Recall Bulletin

SUBJECT: Sensing and Diagnostic Module

MODELS: 2014 Chevrolet Corvette

3923760

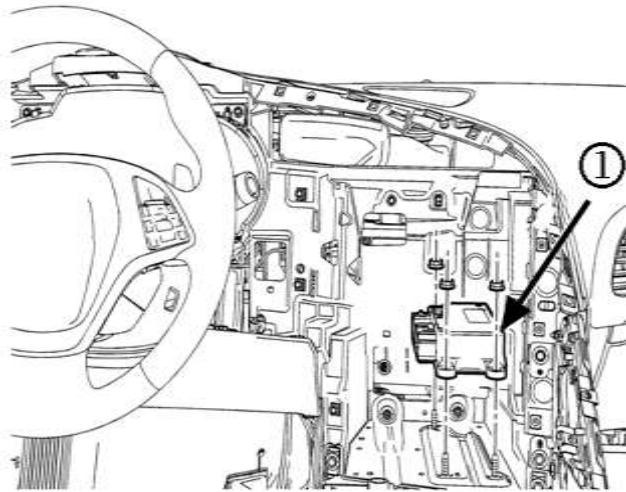
1. Remove the airbag sensing and diagnostic module assembly (1). Refer to *Airbag Sensing and Diagnostic Module Replacement* in SI.
2. Install the new airbag sensing and diagnostic module assembly. Refer to *Airbag Sensing and Diagnostic Module Replacement* in SI.
